TMJ Product Change Notice  
PCN Tracking Number: TMJ-PP-1751

**Subject: <Product Change Notification>  
Change of anti-reflection film**

Comparison figures between current and after changed AR film

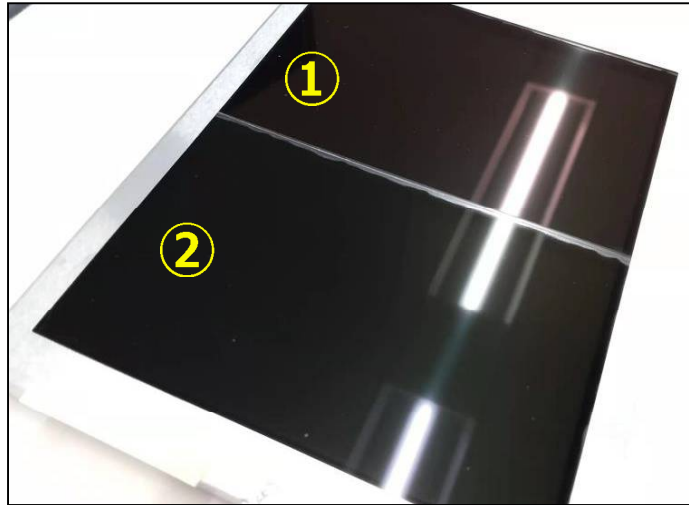
After changed product has reduced reflectance and reflective coloration by optimizing the thickness of the AR layer.
